7.7 Control Systems Not Required for Safety

The information in this section of the reference ABWR DCD, including all subsections and figures, is incorporated by reference with the following departures and supplements.

Figure 7.7-11 Simplified Functional Diagram of the Automatic Power Regulation System

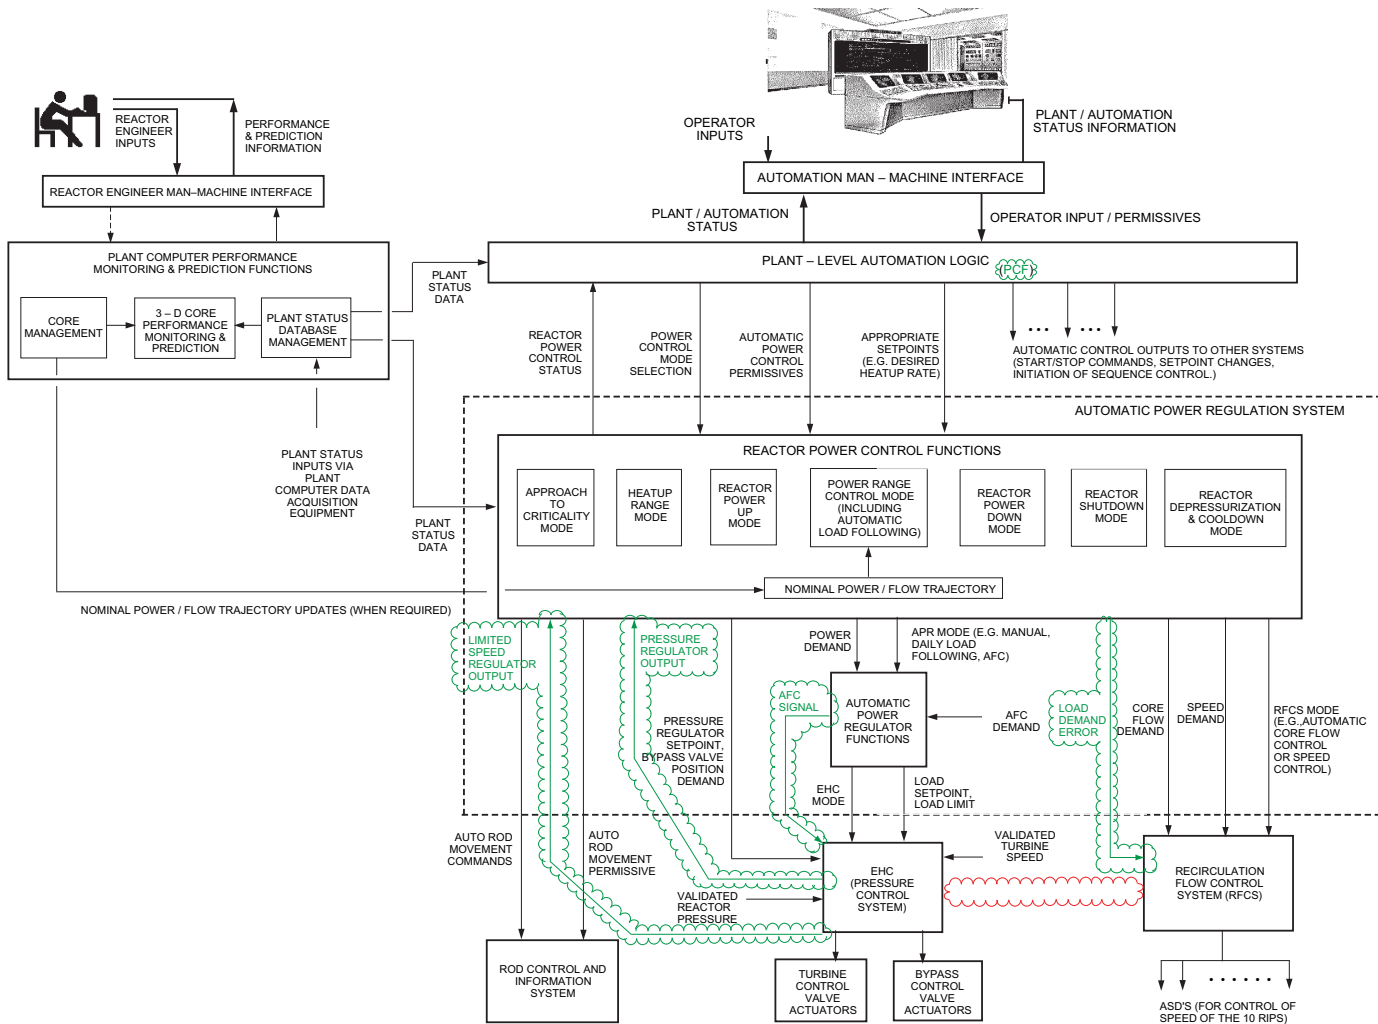
STD DEP T1 3.4-1 (Figures 7.7-2, 7.7-3, 7.7-4, 7.7-5, 7.7-7, 7.7-8, 7.7-9, 7.7-11)

STD DEP 7.7-20 (Figures 7.7-5, 7.7-7, 7.7-11)

STD DEP 7.7-24 (Figures 7.7-11, 7.7-12, 7.7-13)
